## Submission Adur Local Plan Main Modifications

### Response to Submission Adur Local Plan Main Modifications

- 1.1 This note is a response on behalf of Hyde New Homes to the Submission Adur Local Plan Main Modifications published on the 15<sup>th</sup> June 2017.

**Plate 1 Aerial photo taken Mar 2015 showing western portion of New Salts Farm Site.**

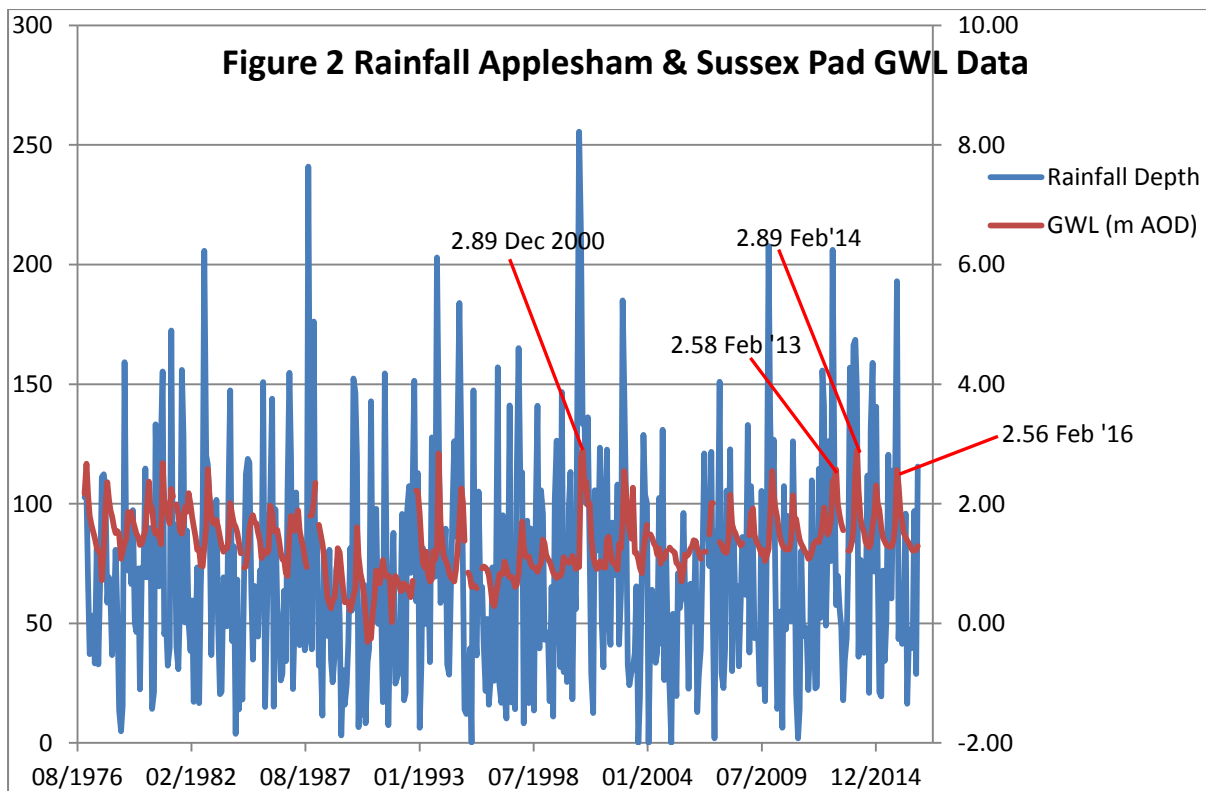
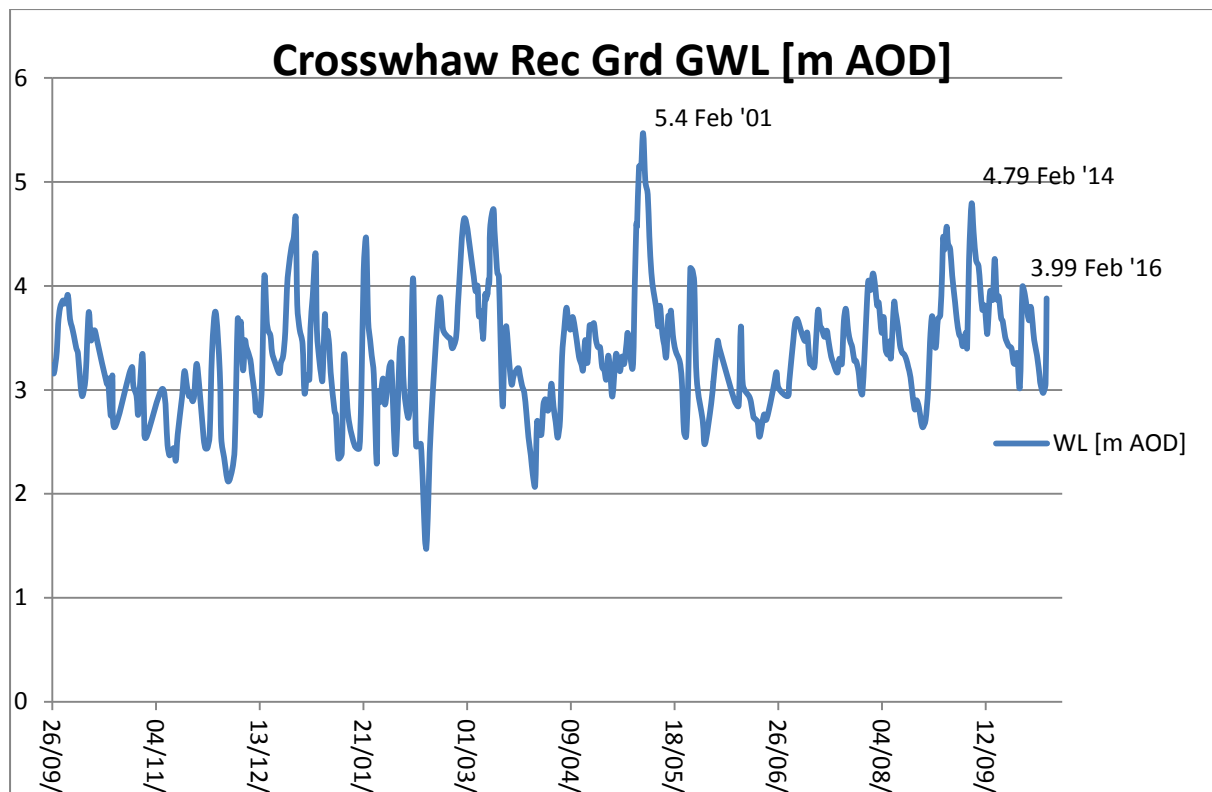
8. The current drainage proposals for New Salts Farm are based upon monitored ground water levels during 2015/16 that the above evidence suggests are below their recent seasonal maxima. The recorded groundwater level of 1.62m AOD at WLS5, approximately 250m from the centre of the proposed detention basin, means that there is ~0.27m depth loss in the storage for the basin (based upon a basin level of 1.35m AOD) and the hydraulic calculations for the extreme storm event would need to take this into consideration. It is suggested that further allowance needs to be made for yet higher seasonal groundwater levels to avoid risk of design-failure.

9. The LLFA is grappling with understanding better the relationship between groundwater levels and surface water flooding, particularly in the coastal plain. To this end, a groundwater study has been commissioned study to address this knowledge gap. The long term aim is to, where necessary, make applications to the RFCC for Local Levy funding for capital works to characterise and where appropriate, alleviate groundwater flooding issues.

**Fig. 2: J12495, New Salts Farm**  
**Groundwater level (Measured Below Ground Level )**

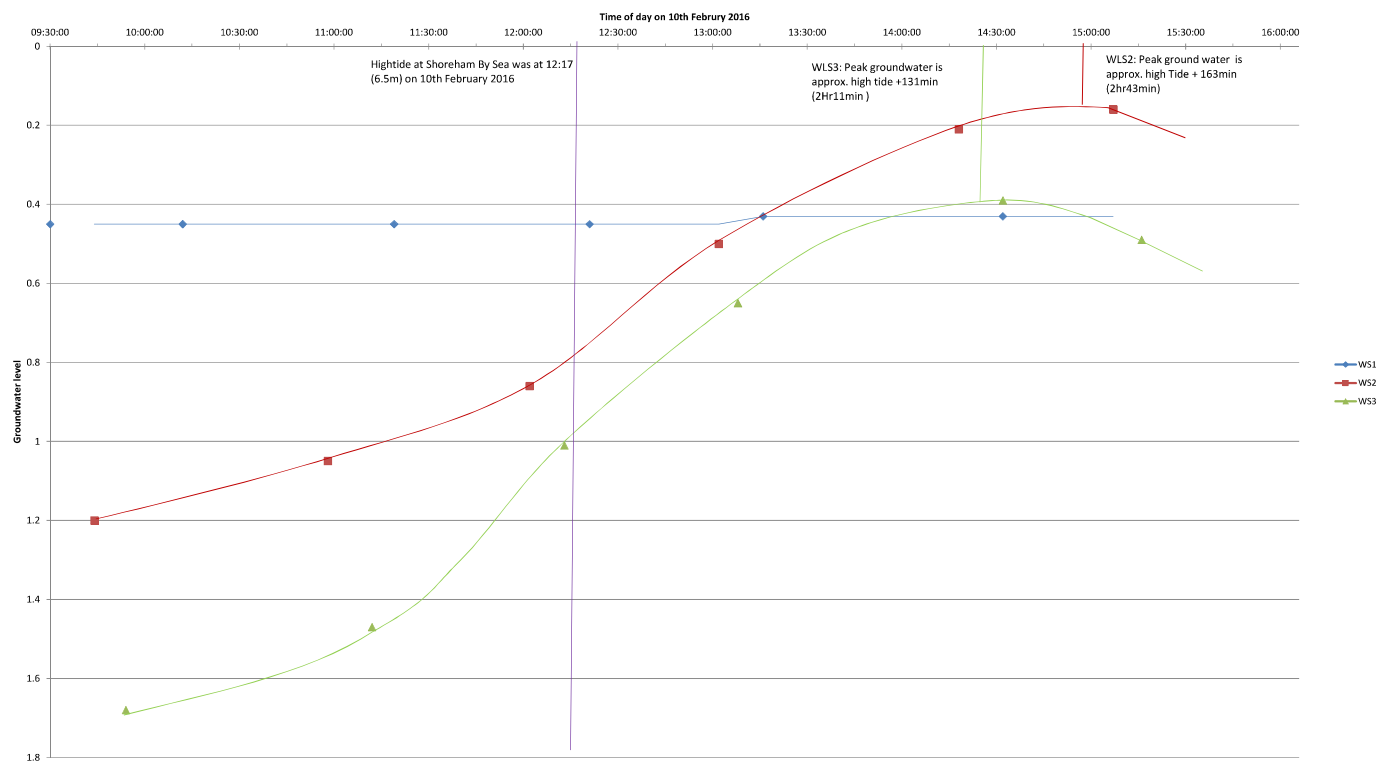
Fig 2 J12495 Depicts ground water levels these appear to show that ground water levels peak two hours after high tide, except in WS1. This has been assessed "and is probably unaffected by tidal action" I would suggest that the ground water level at this location is directly influenced by its proximity to the ditch, a small increase in recorded level is clearly seen, is it more likely that this small peak would coincide with backflow as the tide flaps close.

**Fig 6: J12495, Nedw Salts Farm**  
**Groundwater Level (Measured Below Ground Level)**

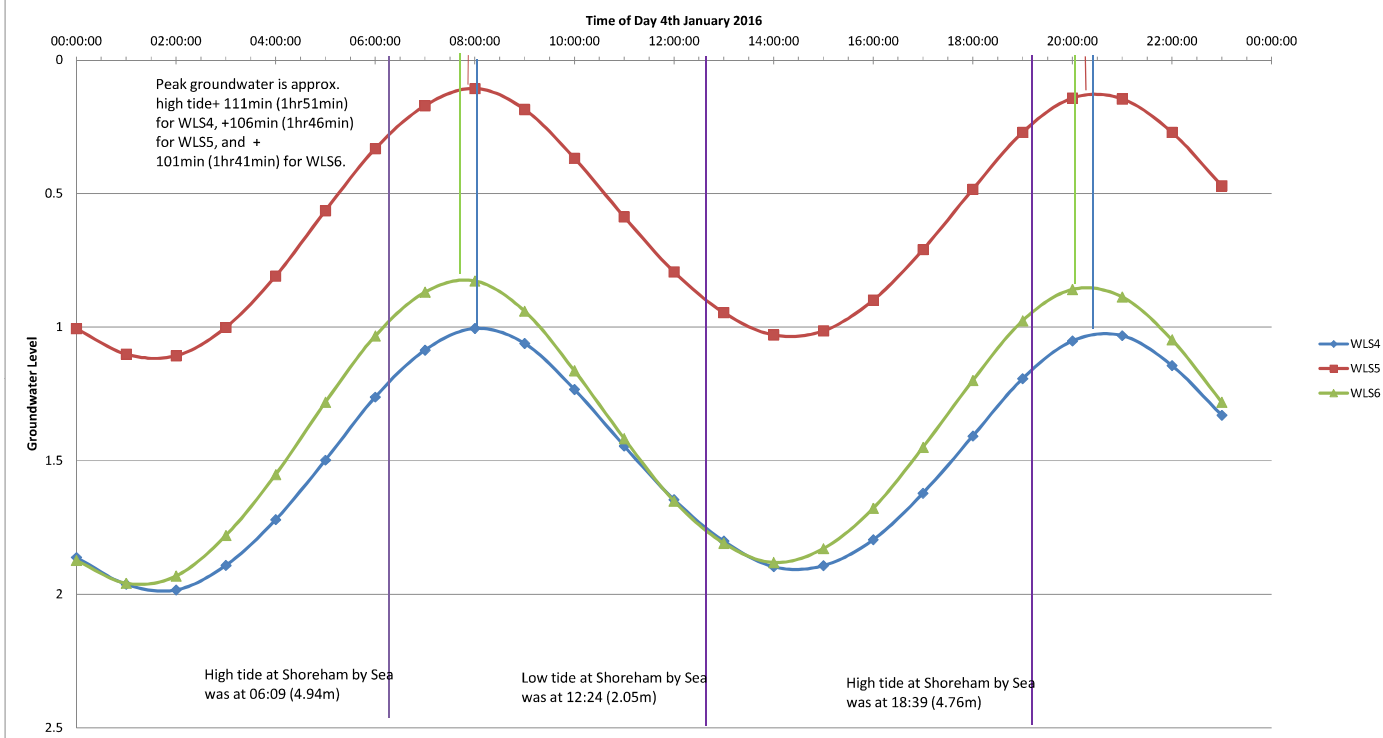
Figure 6 J12495 depicts ground water levels at three locations and shows the tidal lag between high tide and ground water level. It should also be pointed out here that whilst Southern Water confirm that actual rainfall was almost twice the long term average for the month of January a 4.94 m tide is not a spring tide indeed it is almost the lowest high tide level achievable all year. Why was the graph for Monday 10<sup>th</sup> January when the predicted high tide level was 6.1m not be provided

**Plate 1 Aerial photo taken Mar 2015 showing western portion of New Salts Farm Site.**

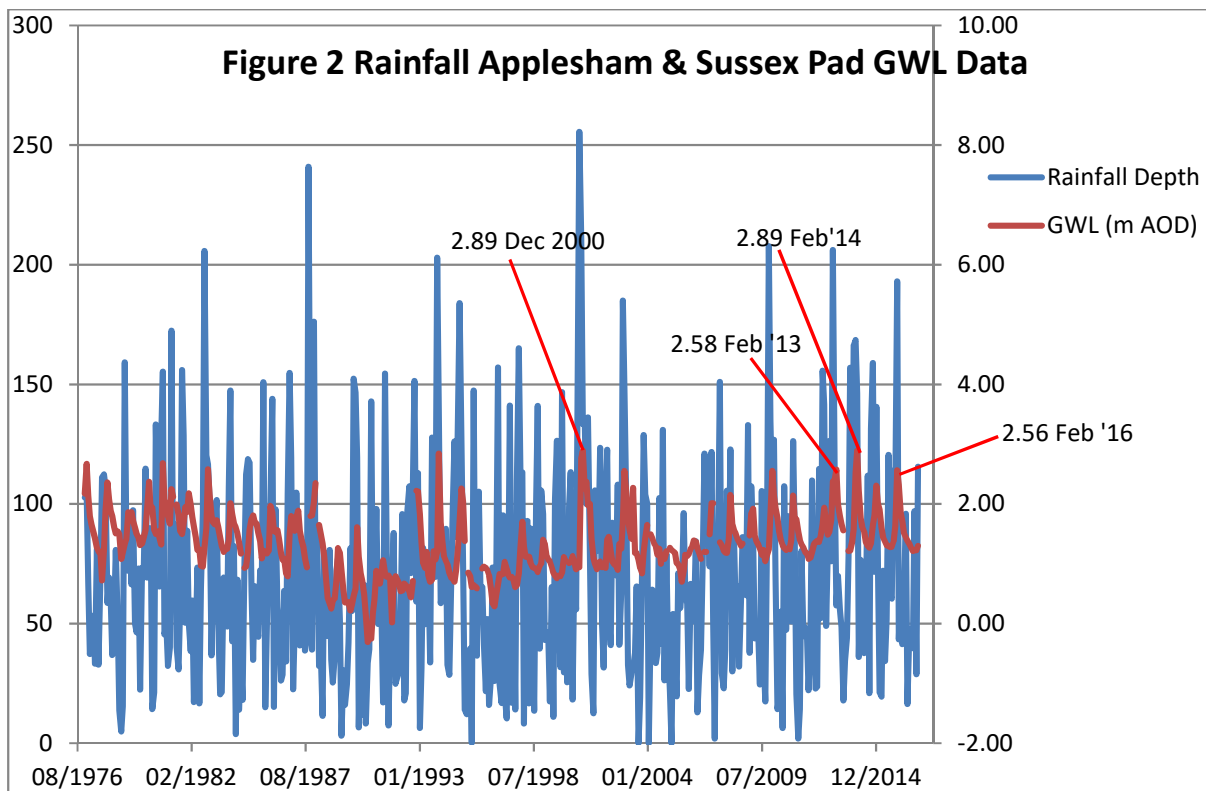
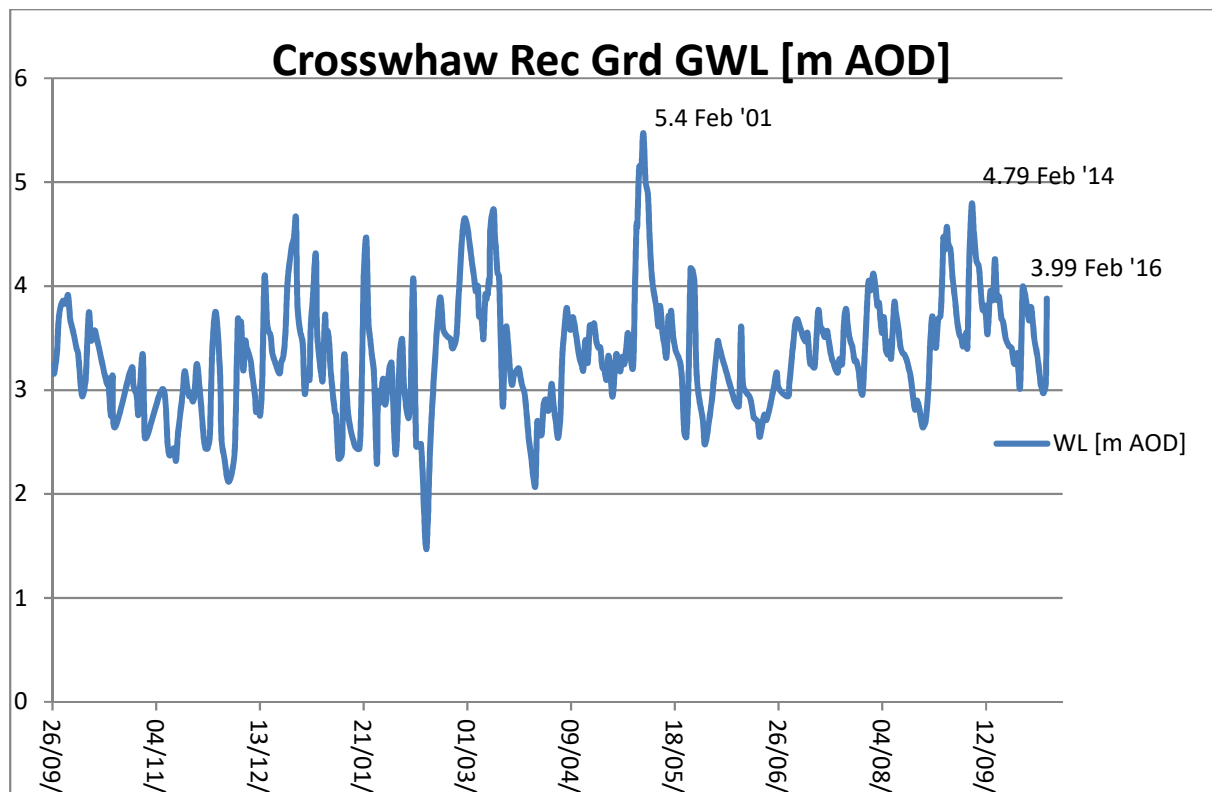
8. The current drainage proposals for New Salts Farm are based upon monitored ground water levels during 2015/16 that the above evidence suggests are below their recent seasonal maxima. The recorded groundwater level of 1.62m AOD at WLS5, approximately 250m from the centre of the proposed detention basin, means that there is ~0.27m depth loss in the storage for the basin (based upon a basin level of 1.35m AOD) and the hydraulic calculations for the extreme storm event would need to take this into consideration. It is suggested that further allowance needs to be made for yet higher seasonal groundwater levels to avoid risk of design-failure.
